SWEDETOWN 90 SUBDIVISION

APPLICATION NUMBER 5 DATE May 5, 2022

REQUEST Subdivision

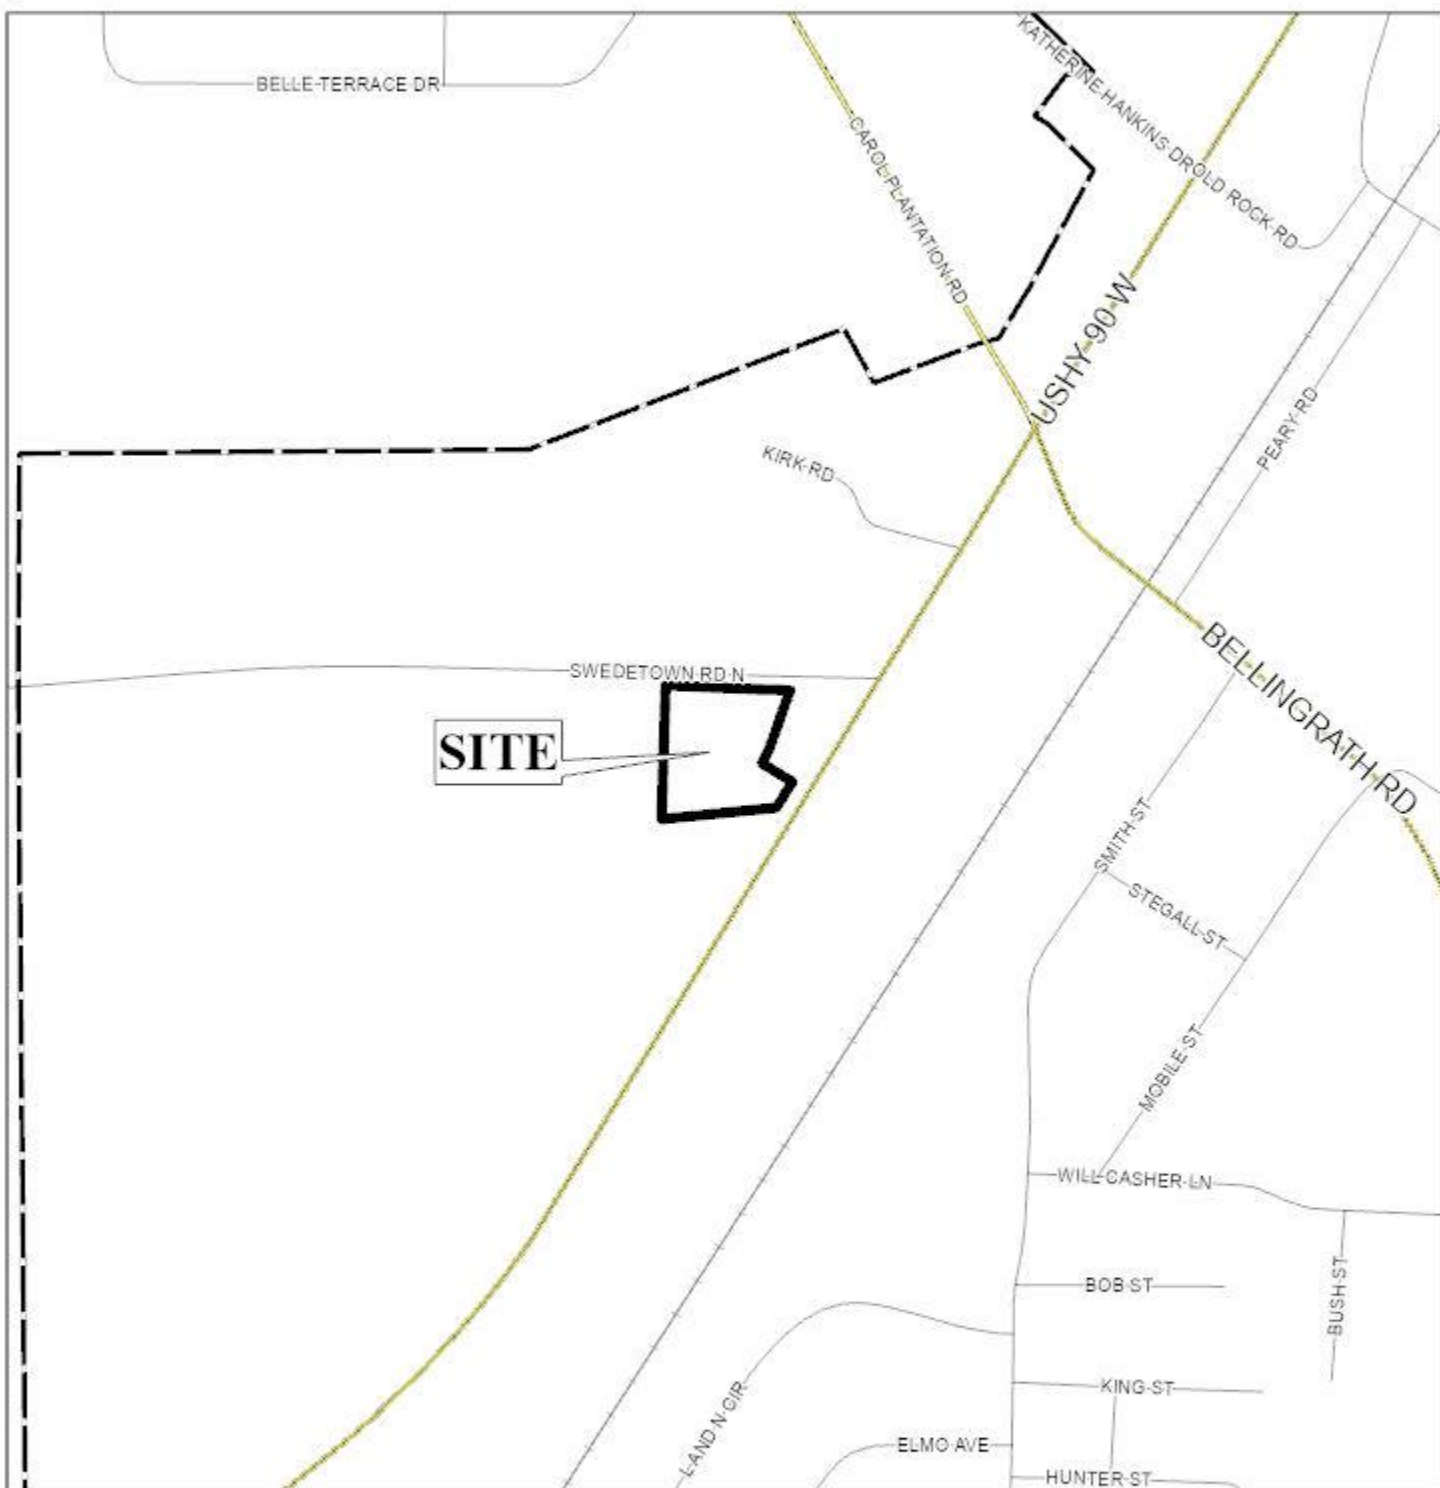
The site has frontage on U.S. Highway 90 West, a major street, and Swedetown Road, a minor street with curb and gutter. As a major street, U.S. Highway 90 West, should have a minimum right-of-way width of 120-feet; as the preliminary plat submitted depicts an existing compliant right-of-way, no dedication necessary is, if approved. As a minor street with curb and gutter, Swedetown Road has an existing, compliant right-of-way of 100-feet, making no dedication necessary, if approved.

The lot sizes are provided in acres, but not square feet, and exceed the minimum lot size requirements of Section V.D.2. of the Subdivision Regulations. If approved, the lot sizes should be provided in square feet and acres.

The preliminary plat shows the required 25-foot setback along both street frontages, and should remain on the Final Plat, if approved.

The proposed lot depicts 10-foot minimum building setback lines along the South and North property lines, where the site abuts other B-3, Community Business District properties. As the site abuts commercial zoning districts, it is allowed either a zero-foot or five-foot setback along the property lines, therefore the 10-foot setback may be removed from the Final Plat, if approved.

The preliminary plat depicts a 20-foot wide drainage easement through the property, and labels it as “to be vacated”. The easement should be vacated prior to the signing and recording of the Final Plat.

The plat submitted also shows a 20-foot wide drainage and utility easement along the West property, where the site abuts R-1, Single-Family Residential property. If approved, a note should be placed on the Final Plat stating that no structures are to be constructed within an easement without the easement holder’s approval.

As per the Traffic Engineering comments, the driveway number, size, location, and design are to be approved by Traffic Engineering and conform to AASHTO standards. A note should be required on the Final Plat stating these comments.

The plat meets the minimum requirements of the Subdivision Regulations, and is recommended for Tentative Approval subject to the following conditions:

- 1) retention of the right-of-way labels;
- 2) retention of the 25-foot minimum building setback line along both street frontages;
- 3) provision of the lot size labels in both square feet and acres on the Final Plat, or the furnishing of a table on the Final Plat providing the same information;
